SUBDIVISION-LAND DEVELOPMENT WAIVER REQUEST FORM

SITE PLAN

Re: 467 Hershey Road (Kevin Grewal)
Land Development Plan Waiver Request
Township Permit No. 25-01-WAIV
LCEC Project No: 25-186

SITE PLAN
SCALE: 1" = 20'

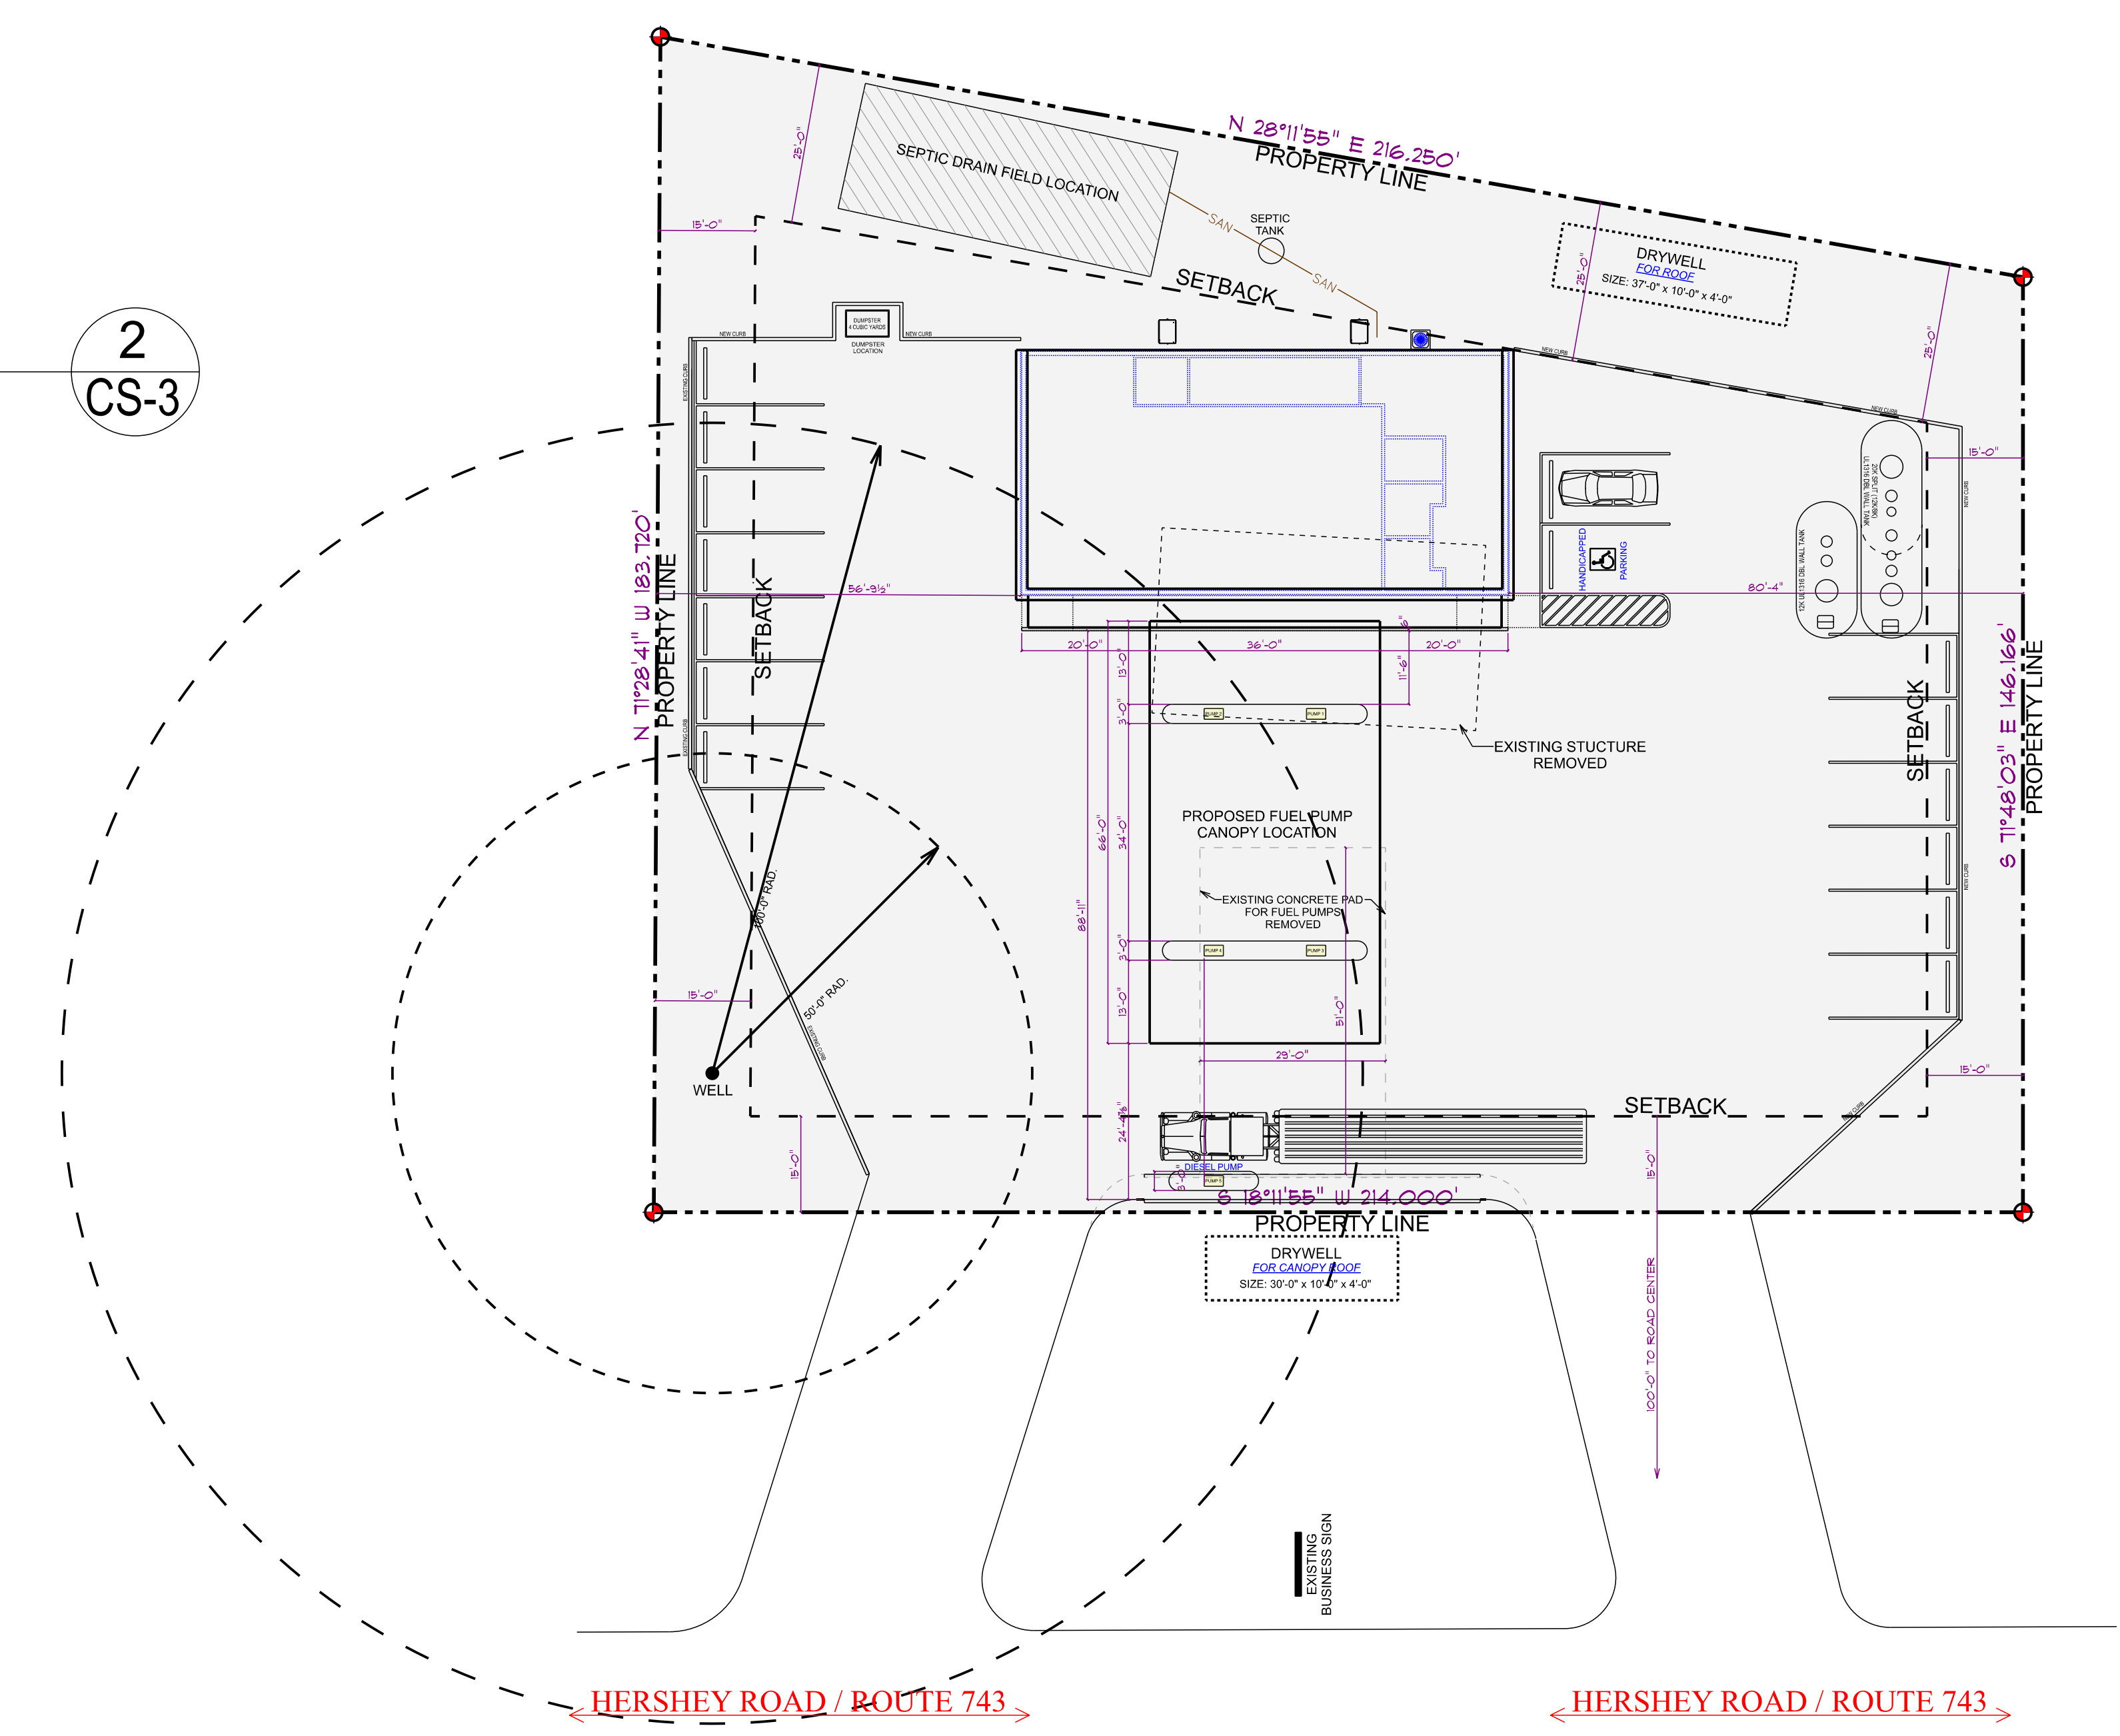
The zoning application and testimony indicated that the existing 1,400 sf building would be re-used for the convenience store; however, the site plan (Sheet 3) shows the existing building to be demolished and replaced with a new 2,900 sf building. The submitted site plan also indicated that the proposed impervious coverage would equal 47.6%; however, it appears that the proposed impervious coverage will be 70%. The Zoning Hearing Board Solicitor should be consulted to determine whether these changes would require another zoning hearing.

2. The minimum front yard building setback line shall be 35 feet from the ultimate street right-of-way (135-145.E(1)(a)). The site plan (Sheet 3) currently shows a 15 foot front yard setback. The proposed fuel canopy (as "structure" as defined by the Zoning Ordinance) is proposed to be located closer than 35 feet to the right-of-way.
3. Off-street parking lots shall be set back at least 10 feet from each side lot line (135-145.E(2)(d)).

4. The total impervious coverage for nonresidential uses shall not exceed 65% (135-145.F(2)). It appears that the proposed lot coverage shown on the site plan (Sheet 3) is approximately 70%.

- e. The access drives shall be designed in a manner that blockage of through traffic by vehicles attempting to enter or exit on these access drives will not occur (119-52.S(4)(c)[2]). The site plan (Sheet 3) shows the northern access drive being partially blocked by a truck.

13. Prior to any earth disturbance, a plan meeting the requirements of the Mount Joy Township Stormwater Management Ordinance shall be submitted to the Township (113-31.A).
14. The site plan (Sheet 3) shows a “drywell” located within the PennDOT right-of-way. Any proposed stormwater management facilities should be located within the property being developed.
